IDE INTERFACE

Title	IDE INTERFACE & PULL UPS
-------	--------------------------

Size	Document Number	8640	Rev	0
Date:	Wednesday, August 28, 2002		Sheet	18 of 32

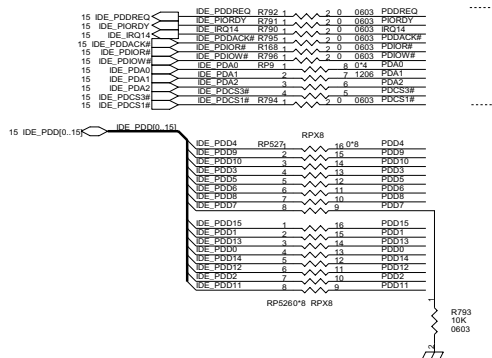
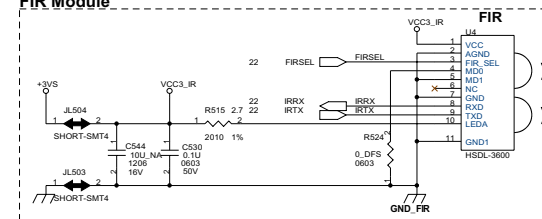
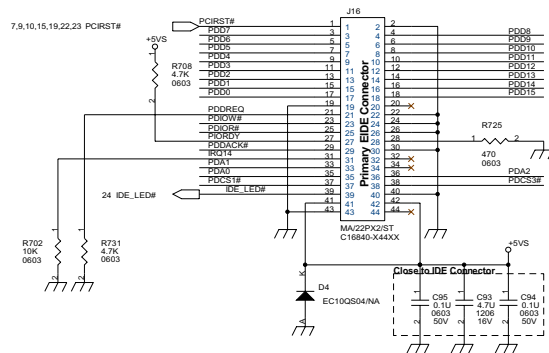
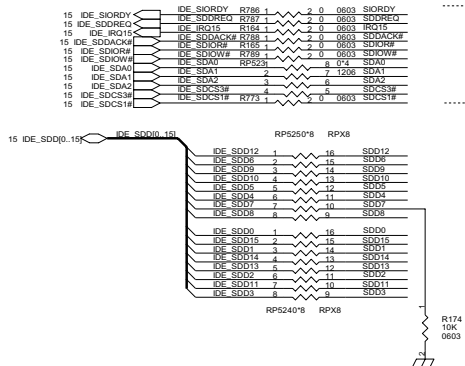
CHANGE TO 0 ohm

Terminating resistors should be place close to South Bridge

Terminating resistors should be placed close to South Bridge
